ADDENDUM NO. TWO

IN136 - IUPUI Athletic and Fitness Center - Replace Fire Alarm System
Indiana University Purdue University Indianapolis
IU 20200540

NUMBER: TWO

NAME: IN136 - IUPUI Athletic and Fitness Center - Replace Fire Alarm System

AEC PROJECT NO: 20-113-03 IUPUI - ATHLETIC AND FITNESS CENTER - FA SYSTEM IU #20200540	
SUBMITTAL: 20200540 BASEMENT PLAN FIRE ALARM	FA100 SCALE: 1/16"=1'-0" SHEET: 6 OF 11
DSN: A. JEHL DRN: N. AMIN CHK: D. JAMES DATE: AUGUST 04, 2021

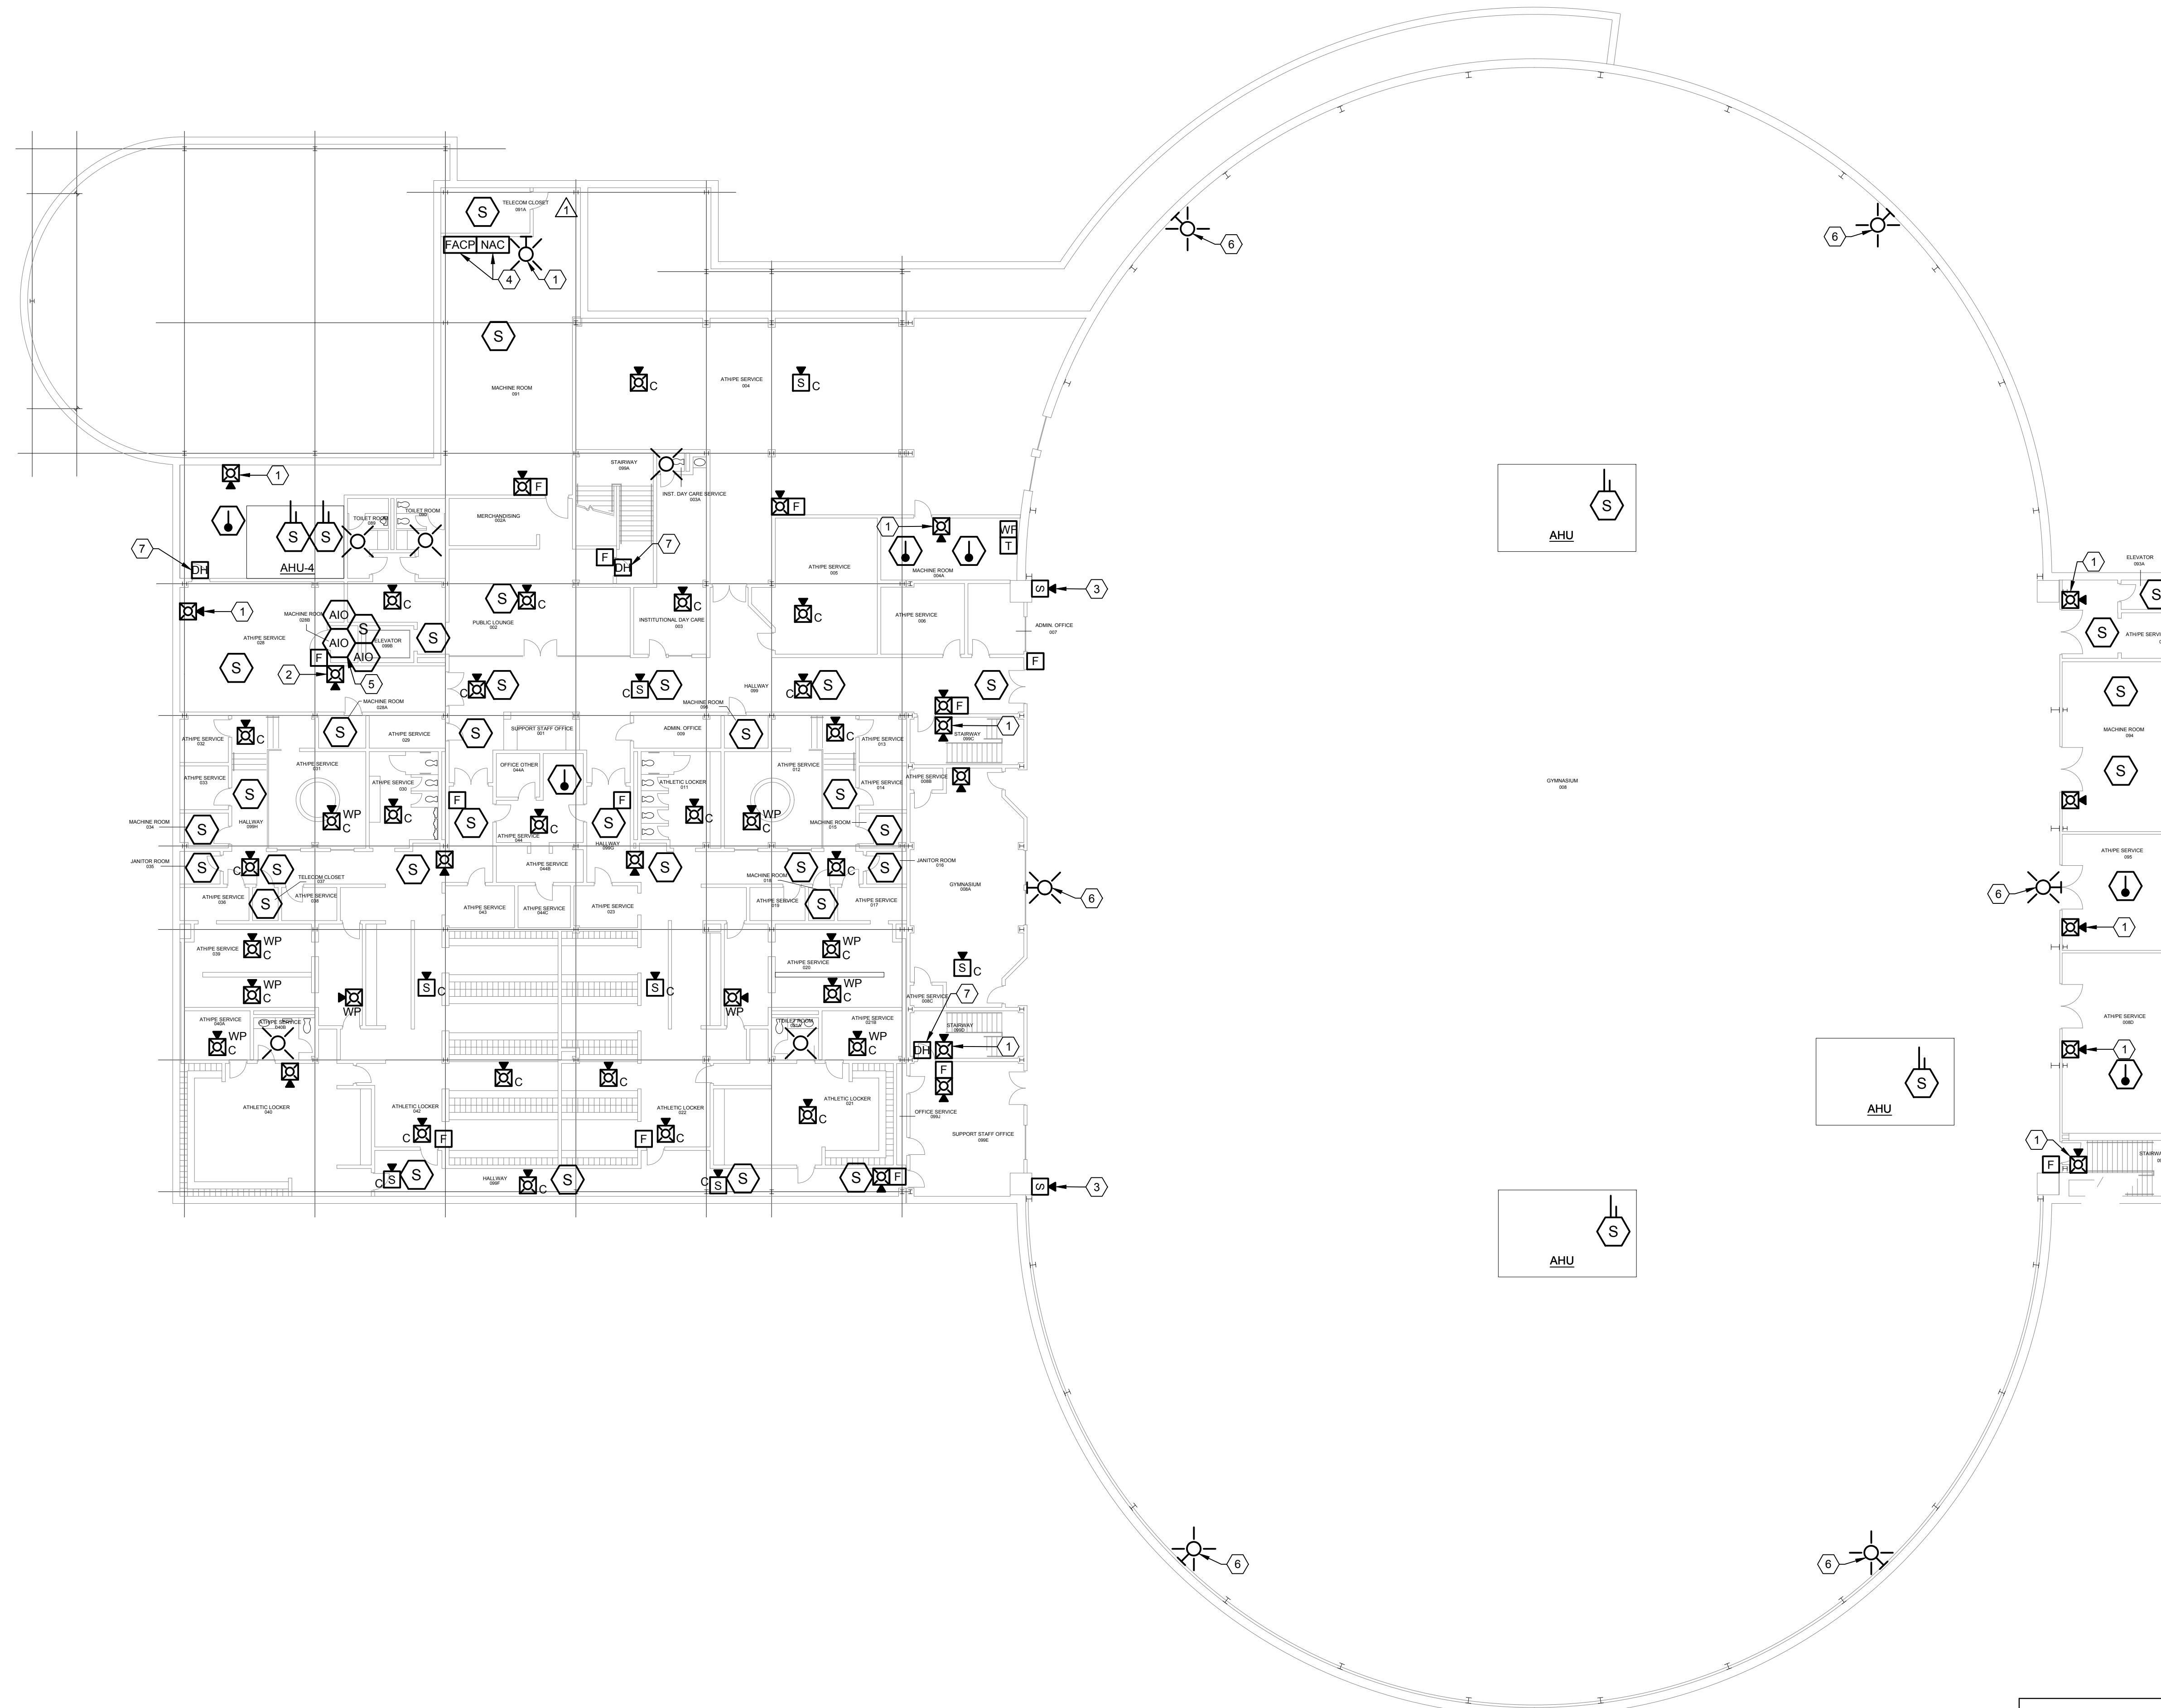
- A. FA100 - Basement Plan - Fire Alarm
 - 1. General Note A now reads "CONDUIT: ALL CONDUIT IN THIS PROJECT MAY BE EMT. THERE IS NO REQUIREMENT FOR RGS CONDUIT IN MECHANICAL ROOMS."

- A. CONDUIT: ALL CONDUIT IN THIS PROJECT MAY BE EMT. THERE IS NO REQUIREMENT FOR RGS CONDUIT IN MECHANICAL ROOMS.
- B. NEW DEVICES WILL NEED TO BE ADDED TO SUPPLEMENT VOICE CLARITY WHERE INDICATED. ALL NEW DEVICES IN ANY AREA, WHERE NOT CEILING MOUNTED, SHALL MATCH ROUGH-IN TYPES (IE, IF EXISTING DEVICES IN AREA ARE FLUSH MOUNTED, ANY NEW DEVICES ADDED IN THE AREA SHALL BE FLUSH MOUNTED AS WELL.)
